**SECTION 87F REPORT OF NEIL THOMAS – GROUNDWATER**

**MANAWATŪ-WHANGANUI REGIONAL COUNCIL, GREATER WELLINGTON  
REGIONAL COUNCIL, TARARUA DISTRICT COUNCIL AND MASTERTON DISTRICT  
COUNCIL**

**15 MARCH 2024**

**FIGURE 1: Geological map and bore locations**

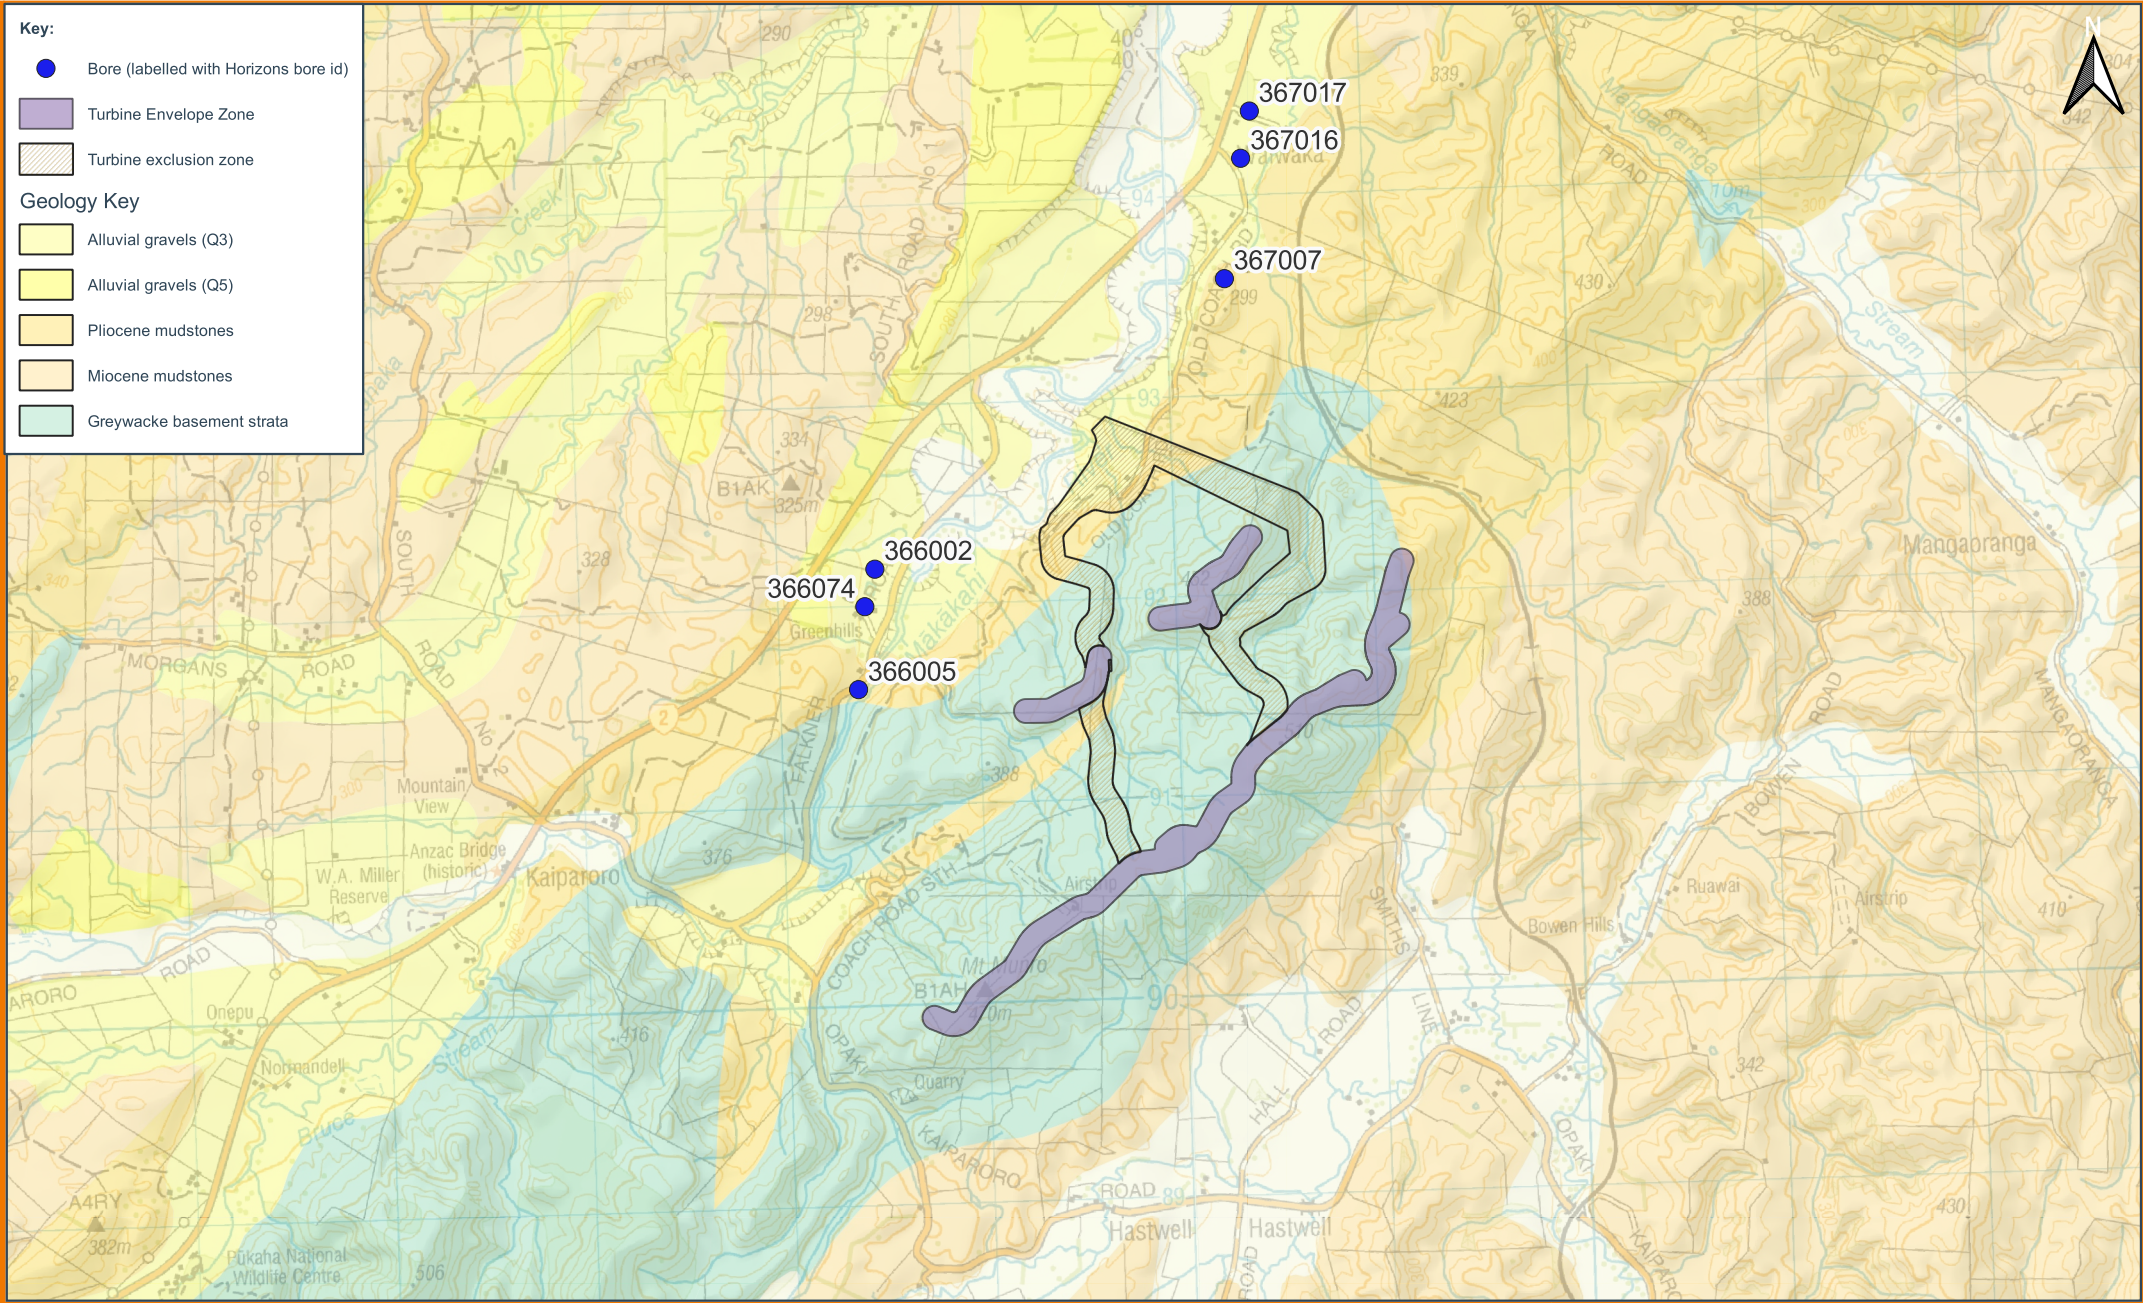
- 17 A map of the proposed site is shown in Figure 1 (attached to my report), which shows the approximate location of the turbines (the turbine envelope) on a geological map of the area. In addition, the location of registered bores on the Horizons database are shown.

- 18 The proposed site is on a broad, elevated ridge of basement strata, which consists of low permeability sandstones and mudstones. Along the top of the ridge, the low permeability strata is overlain by colluvium, which can be several metres thick in places. The colluvium sediments are made up of silts and sands (based on test pit descriptions provided in Appendix F to the application AEE) and appear to host a local groundwater resource 1 to 3 m

- 20 Away from the ridge where the turbines will be located and to the north-west are the upper reaches of the Mākākahi River, the geological map indicates that the strata along the Mākākahi River valley include recent gravelly river deposits and there are six groundwater bores located within these sediments, close to the base of the Mt Munro Ridge. Only one of these bores has a recorded depth (2 m, Horizons bore id:366002) and no depth is recorded on the Horizons database for the other bores. However, I would expect that these other bores are also shallow, with a potentially good hydraulic connection to the nearby river. I expect that these bores are shallow because the lower permeability mudstone strata outcrops on either side of the river valley and likely underlies the main river valley.
